1728 Fortis South Steyne

34-35 South Steyne Manly NSW

TITLE	GA Elevation North & South Elevations
-------	--

GA Sections Section AA, BB & EE

DRAWING NO. A-DA-310-001

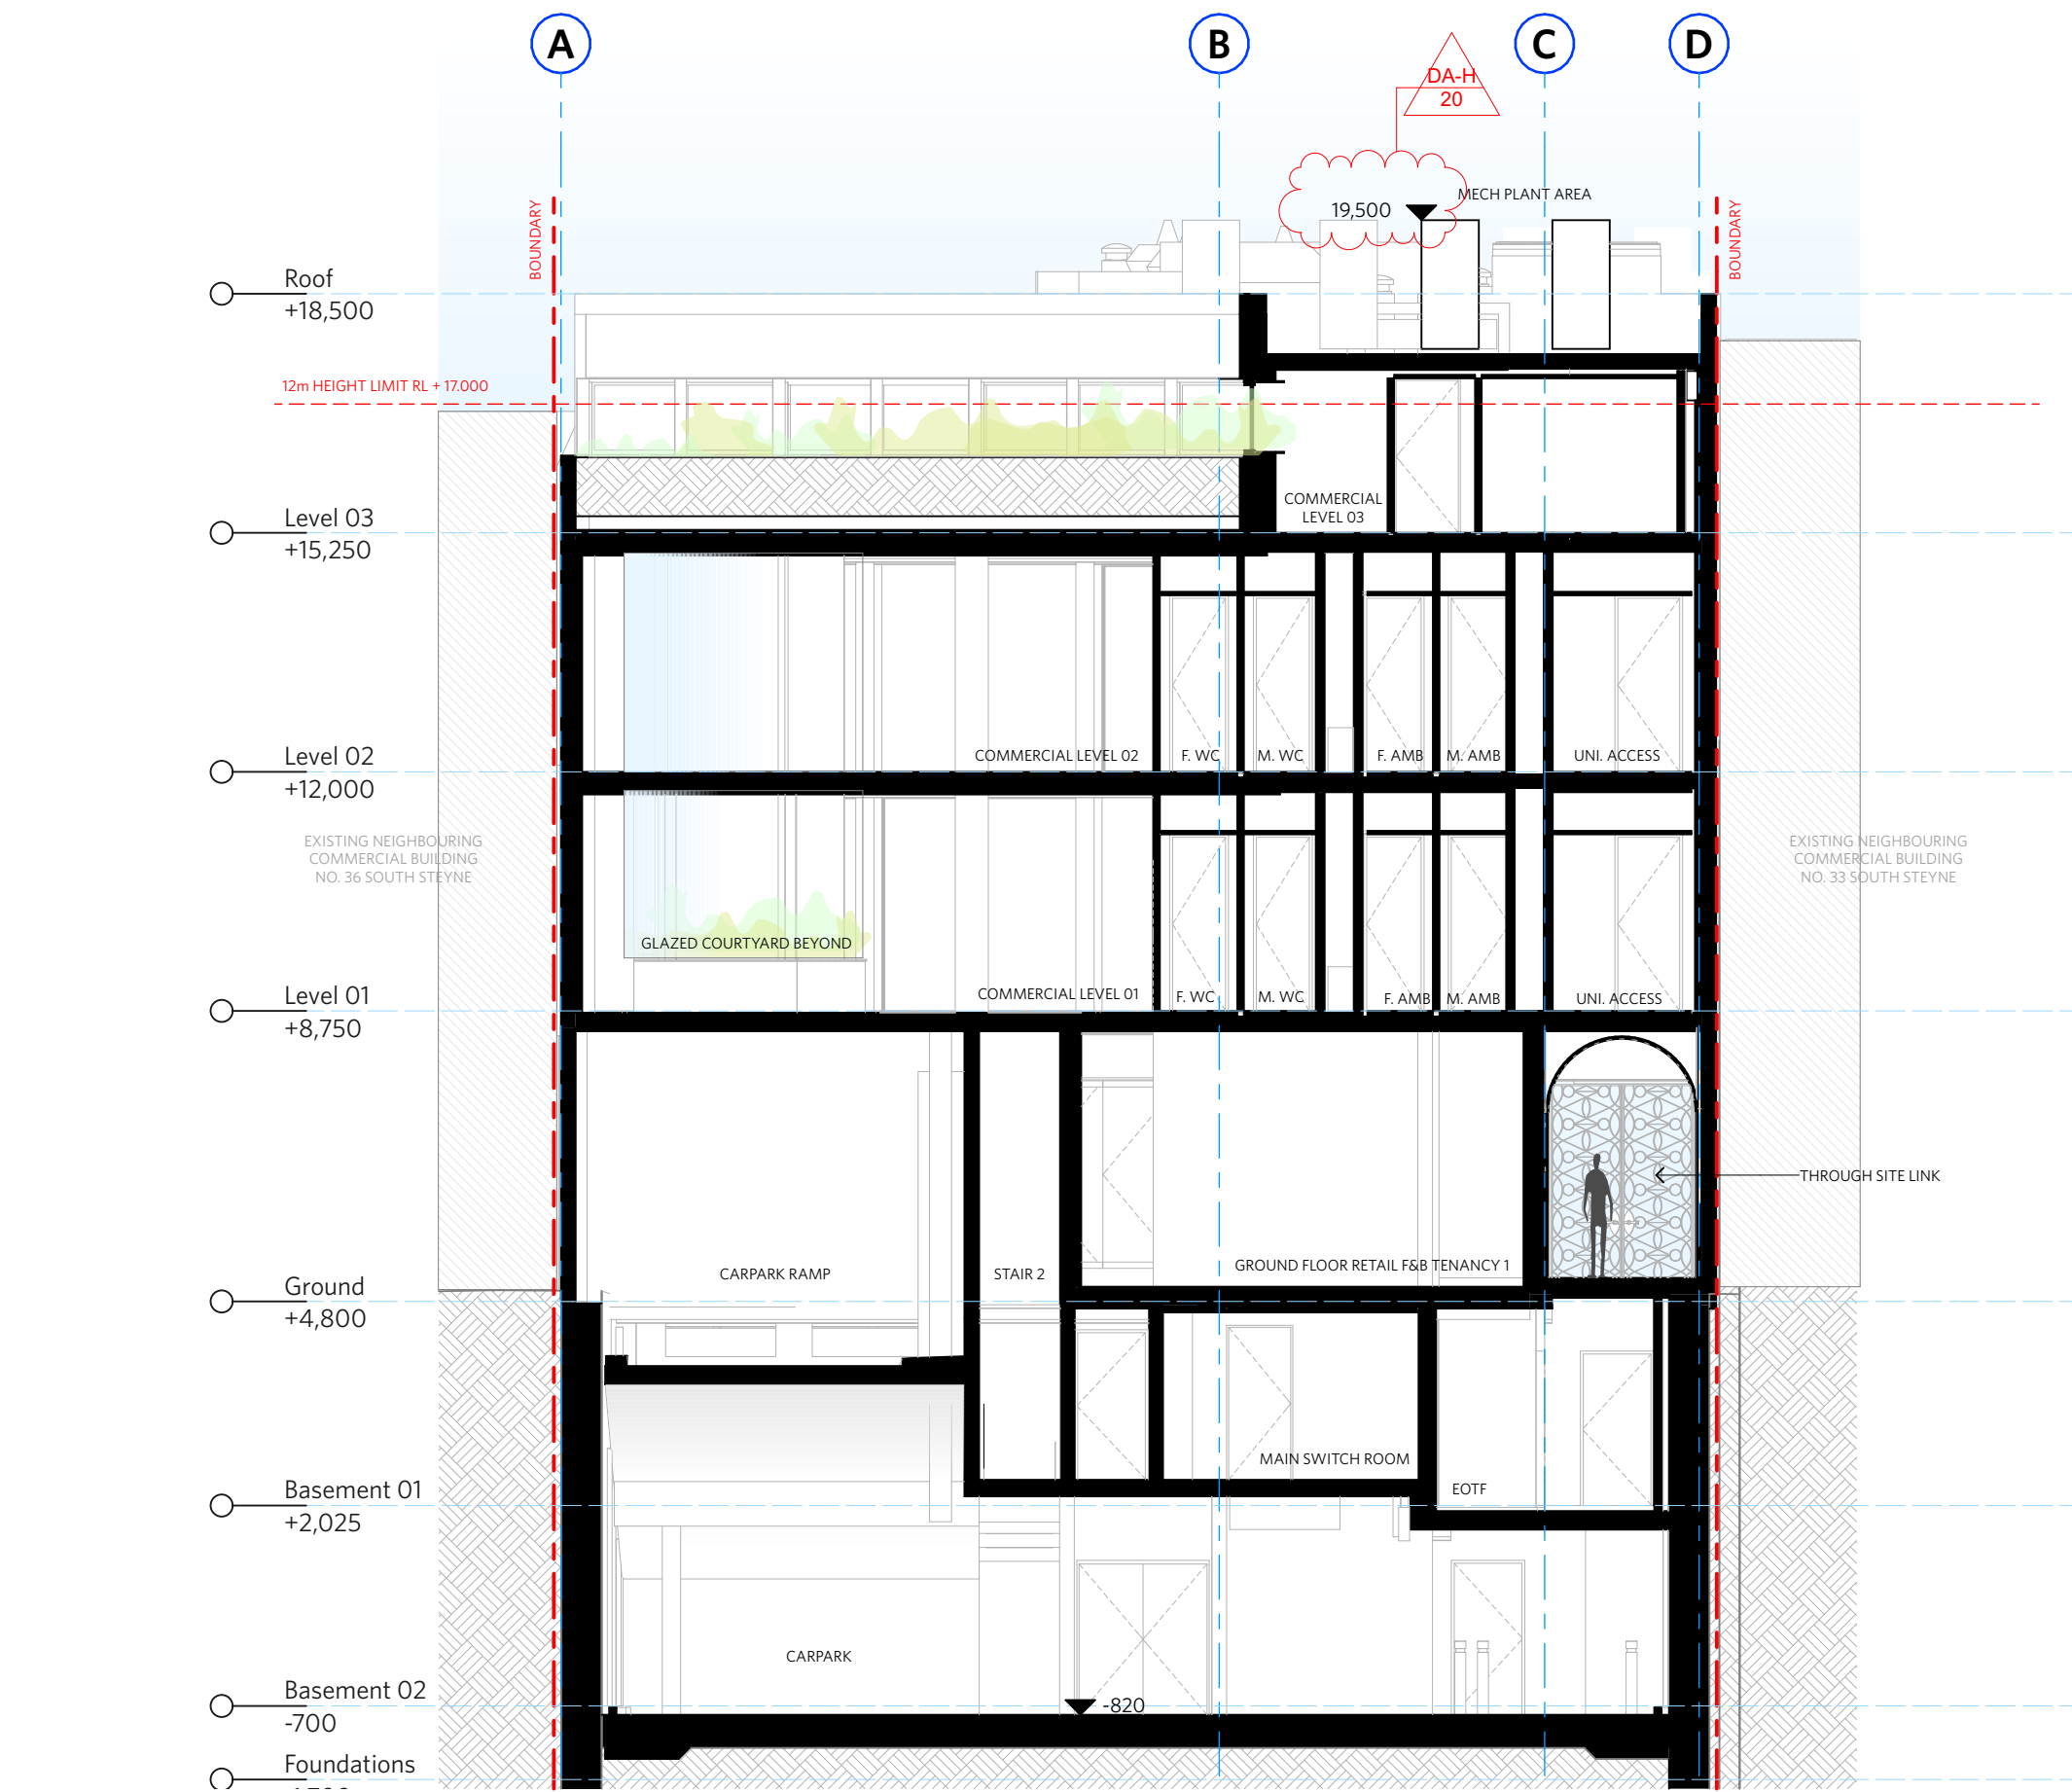
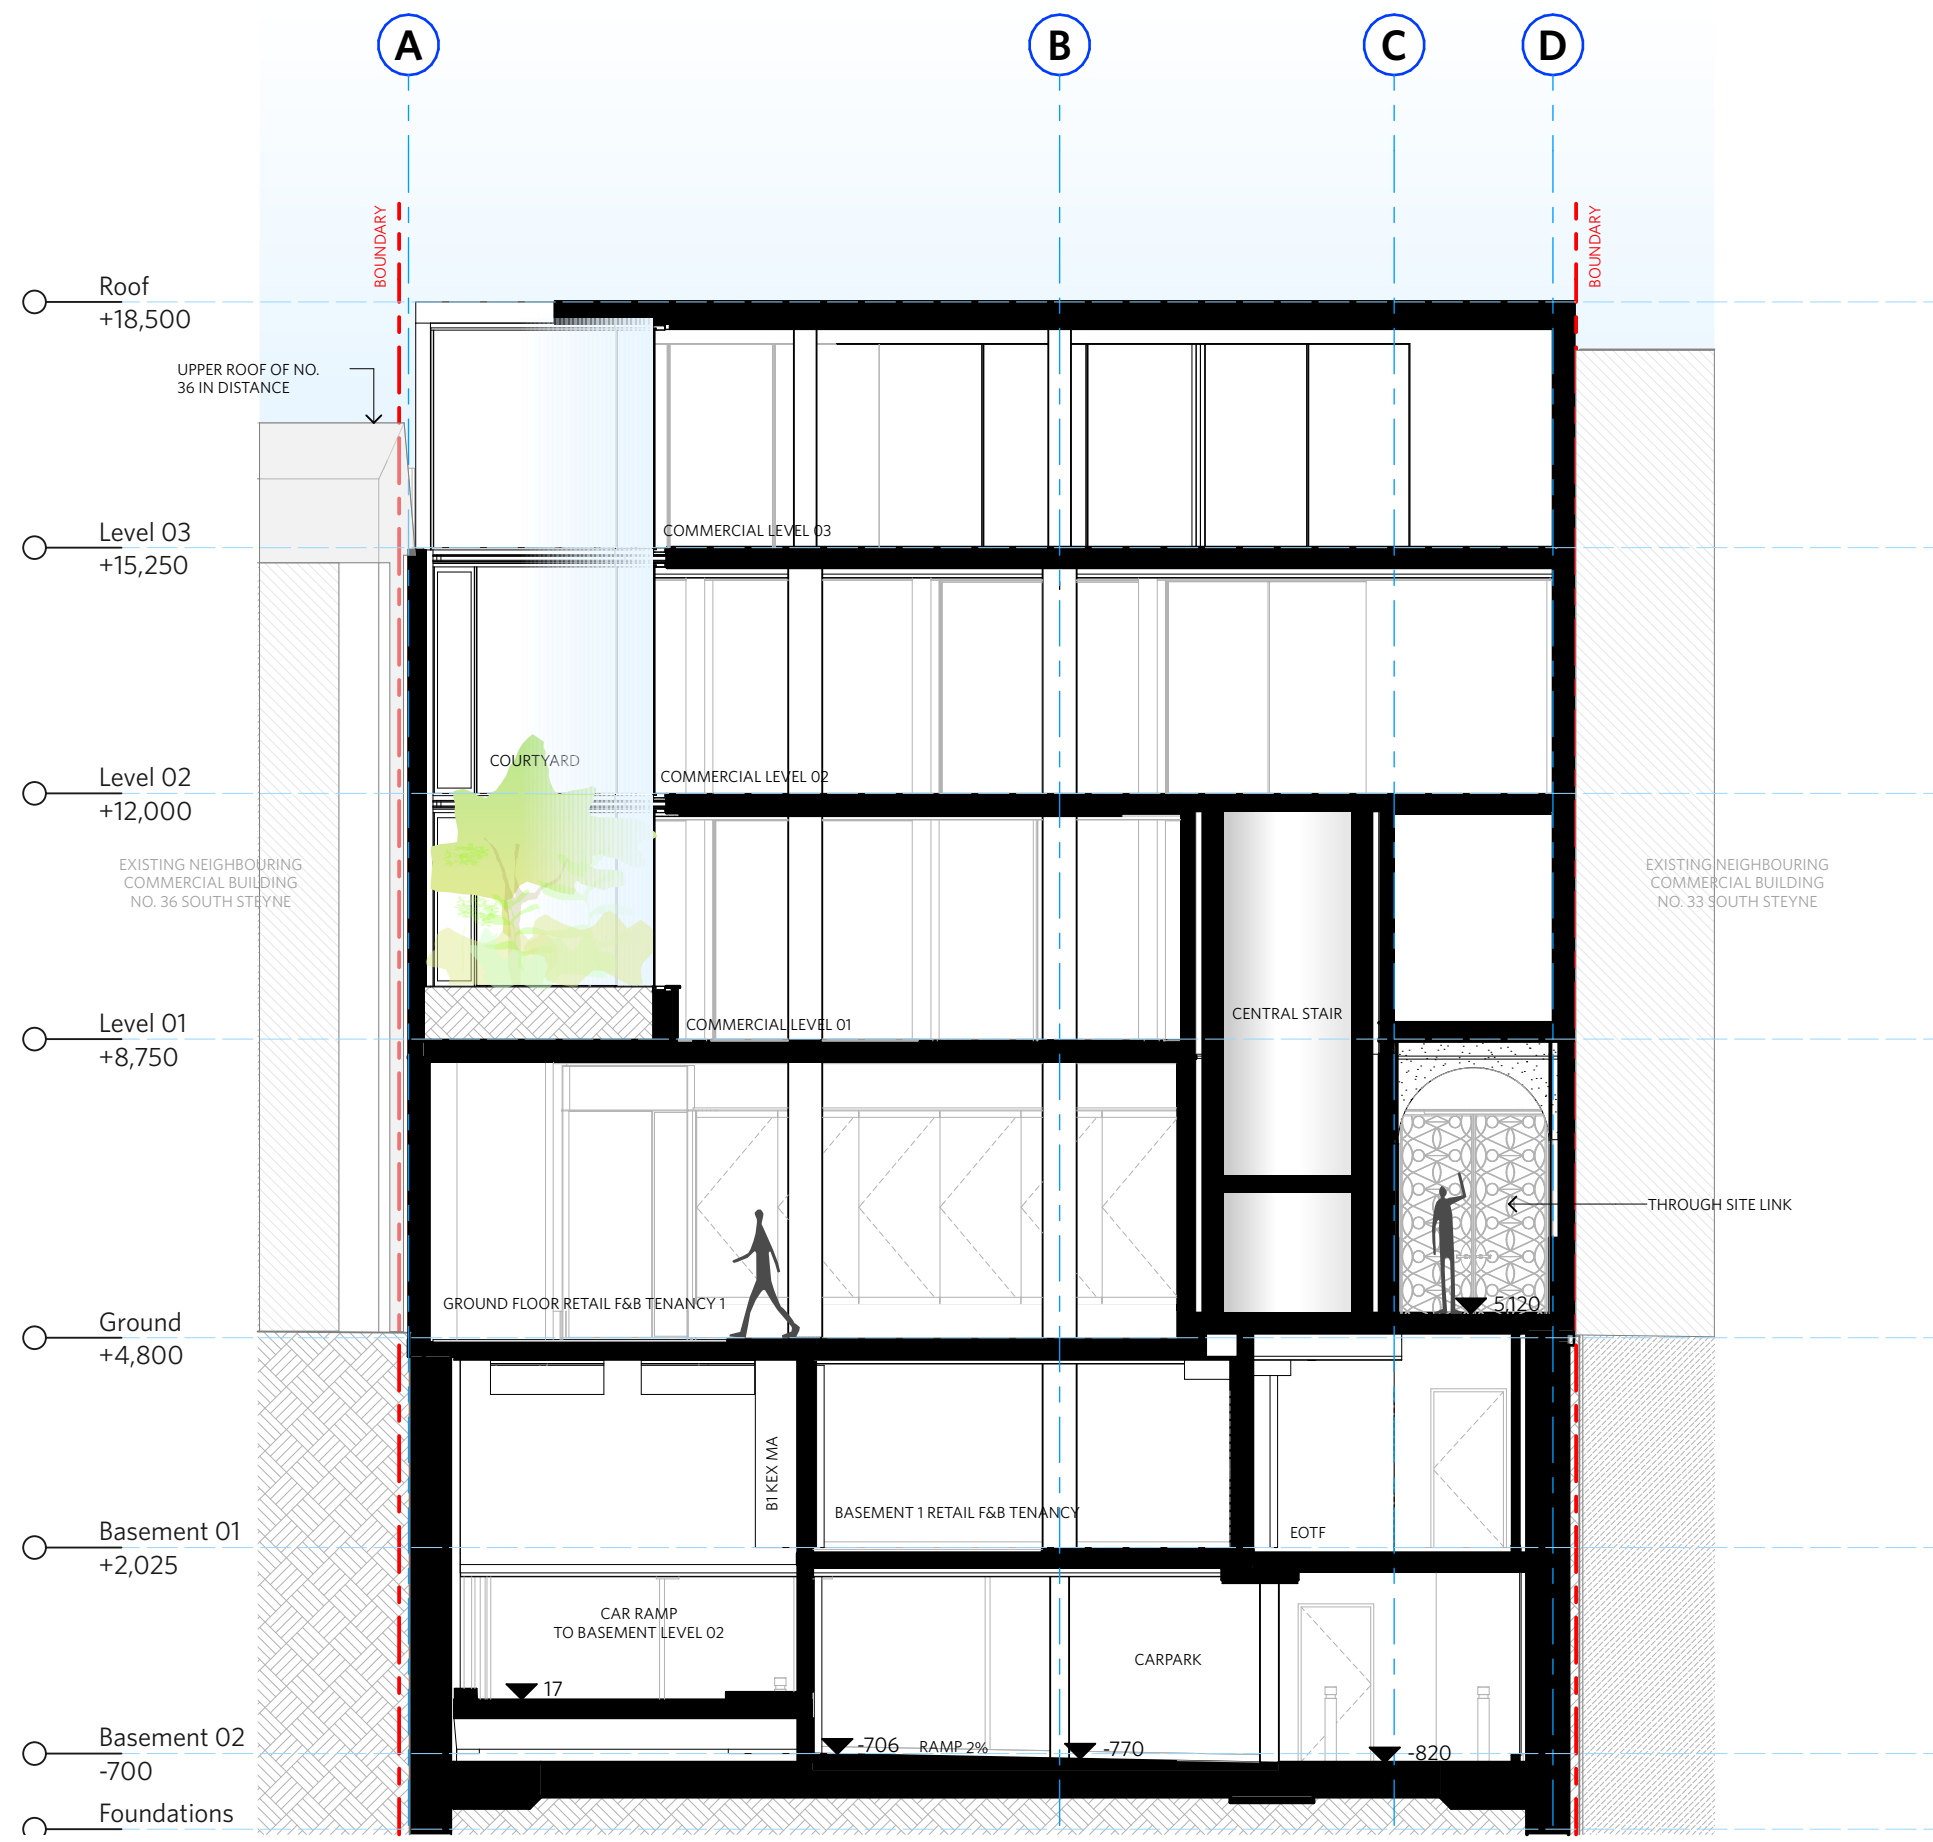
REV	CHANGE	DESCRIPTION
DA-H	20	RL Added for Mechanical Plant
